December 31, 2024

**Breeka Li Goodlander, Conservation Agent
Town of Franklin
Conservation Commission
355 East Central Street
Franklin, Massachusetts 02038**

**RE: 55 Constitution Boulevard
Notice of Intent (BETA Peer Review Response #2)
MassDEP File No. 159-1031**

Infiltration System 1

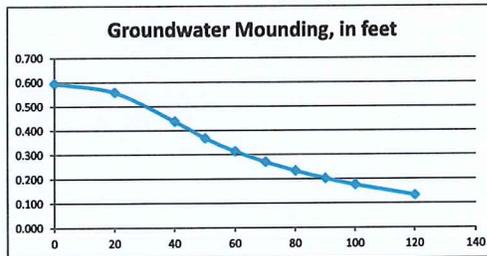
The Applicant proposes two subsurface infiltration basins. Test pit data was not provided for the location of the larger subsurface infiltration system. Test pit data is required at the location of any infiltration BMP, one sample for every 5,000 sf of basin to verify seasonal high groundwater and soil type. The Applicant should provide recent test pit information and confirm the depth is at least 2 ft to SHGW and/or bedrock at all areas of proposed infiltration. If less than 4 ft to SHGW, a mounding analysis is required. A detail on the separation from SHGW should also be provided. See V2, Ch2, p88 of the MA Stormwater Handbook. Has a mounding analysis been conducted for Subsurface infiltration basin #1 as SHGW is shown to be within 4ft to the bottom of the structure?

The project only proposes a single infiltration system. It is believed that the reviewer may have thought the system closest to the building was also an infiltration system, but it is designed as a detention system only with no provision for infiltration. For the single infiltration system, two test pits have been performed for the 2,800 +/- sf system. The bottom of the system is at elevation 338.30 and the ESHGWT is at 336.30. A mounding analysis has been performed for Infiltration System #1 and is shown in Attachment B of this response letter.

Infiltration Rate 'R'
 =(Recharge Volume)/(Area x Duration)
 =4,142 CF / (2800 SF x 3.0 Day)
 =0.49 Ft/Day

100.598	h(max)	maximum thickness of saturated zone (beneath center of basin at end of Infiltration period)		
0.598	Δh(max)	maximum groundwater mounding (beneath center of basin at end of Infiltration period)		
Ground-water Mounding, In feet	Distance from center of basin, In feet
